My Ref: BG-296-221019-Rpt29-DRAFT

Glenorchy City Council

REVIEW OF LANDSLIDES FOR GCC  
REPORT 29 – 19 October 2023

Figure 1 Critical survey monitoring points (in red) and groundwater monitoring boreholes (in blue).

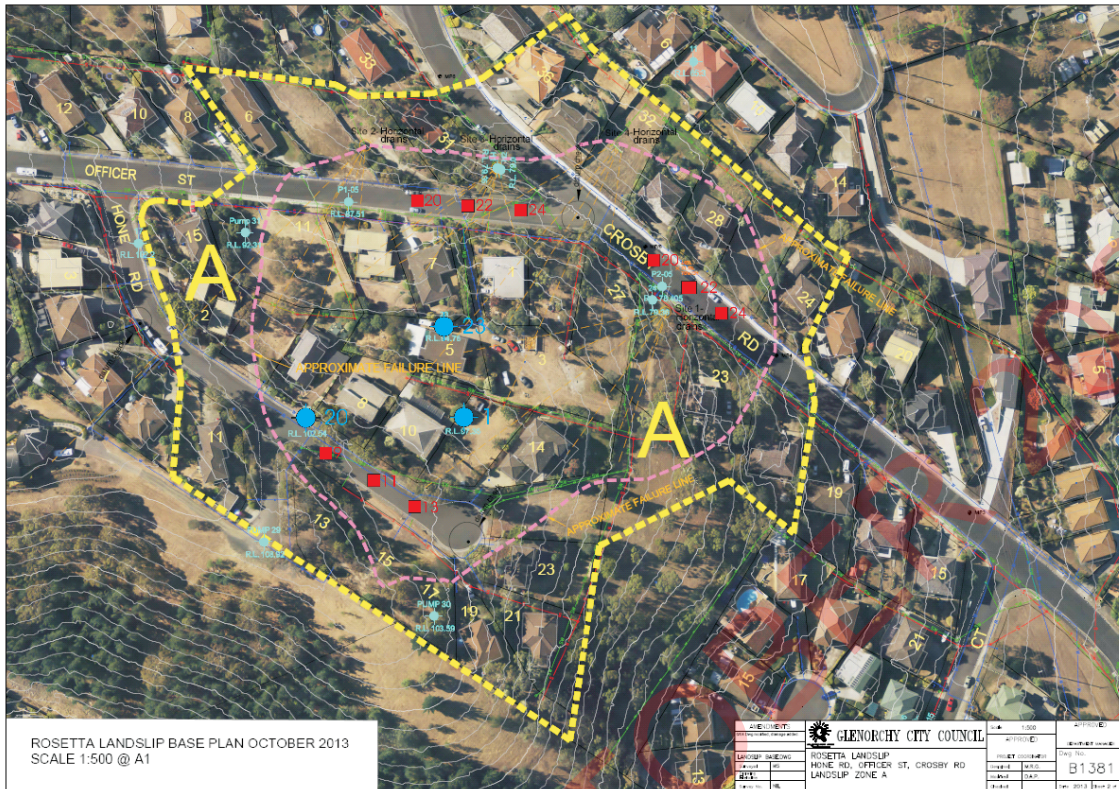
The last survey was in August 2023. There continues to appear to be a long-term trend of settlement or slight landslide downwards movement of between 15 and 20 mm over the last 10 years in this area, with little in the way of lateral movements, which is consistent with the location of these monitoring points within the upper part of landslide, where downward movements would be anticipated. There is no significant movement of the landslide. Comment remains unchanged.

The last survey was in August 2023. There appears to be a long term trend of settlement and lateral displacement of between 10 and 15 mm over the last 10 years in this area with survey point 24 showing possibly 15 to 25 mm settlement over the same period, although this localized movement may have stabilized over the last few years. There is no significant movement of the landslide. Comment remains unchanged.

The last survey was in March 2023. The three monitoring points may have settled by between about 5 to 10 mm over the last 10 years. There is no significant movement of the landslide. Comment remains unchanged.

Groundwater levels in boreholes 1 and 20 continue to be below levels at which immediate actions are required, which indicates that the pumping and the gravity drainage is being successful in maintaining lower groundwater levels. However, the temporary malfunction of pump 31 appears to have caused an increase in groundwater level in borehole 23 to a level of 7.8 m below the surface. No landslide movements appear to be associated with this rise in groundwater levels and pump 31 has been replaced and commissioned. The observed increase in groundwater levels requires an action under the Landslide Management Plan (Section 3.4, Item 5 of Landslip Management Manual\_Rev10.0.pdf). However, as the pump has been replaced, it is suggested that this action should suffice to meet the intent of Section 3.4, provided that the groundwater levels in borehole 23 drop down to more than 10 m below the surface in the next few months. This incident illustrates the need to continue with the pumping but also the need to respond proactively to the results of the monitoring in a timely fashion.
